B I D A D D E N D U M 0 4

The items set forth herein, whether of omission, addition, substitution, or clarification are to be included in and form a part of the construction documents for the project listed above.

ORANGE-ULSTER BOCES
AXELROD - MAIN
BUILDING
ADDITIONS +
ALTERATIONS
53 GIBSON ROAD
GOSHEN, NY 10924

5 BOYS 434B DOMESTIC WATER RISER DIAGRAM
NOT TO SCALE

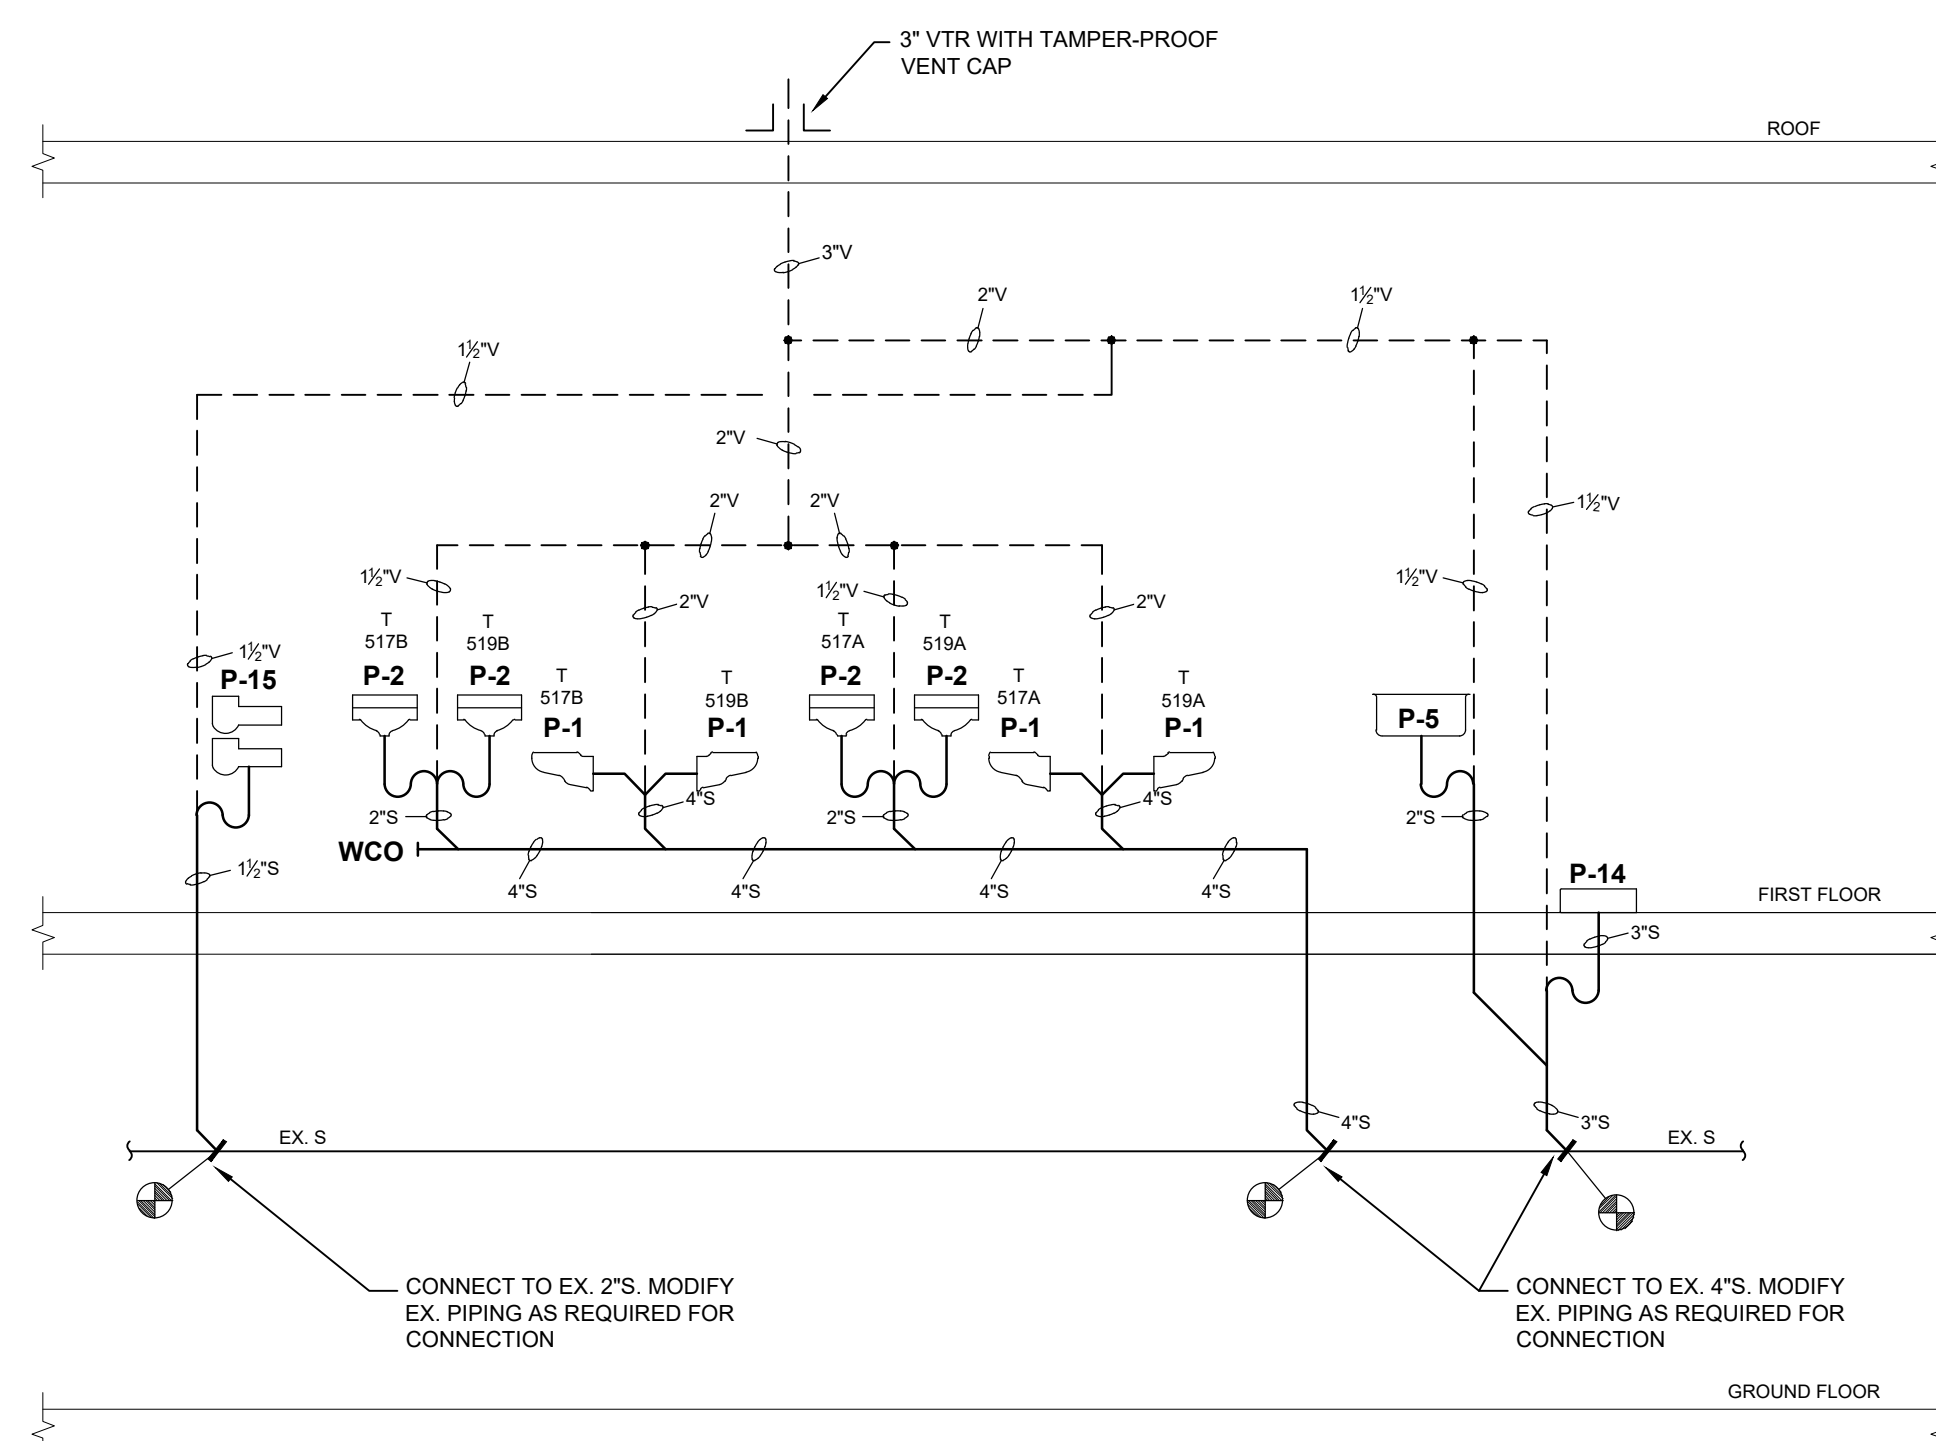
Drawing P201D – Plumbing First Floor Plan Part D
- 6.2 Attached please find attached new Plumbing Drawing P602 – Plumbing Details with riser diagram information.
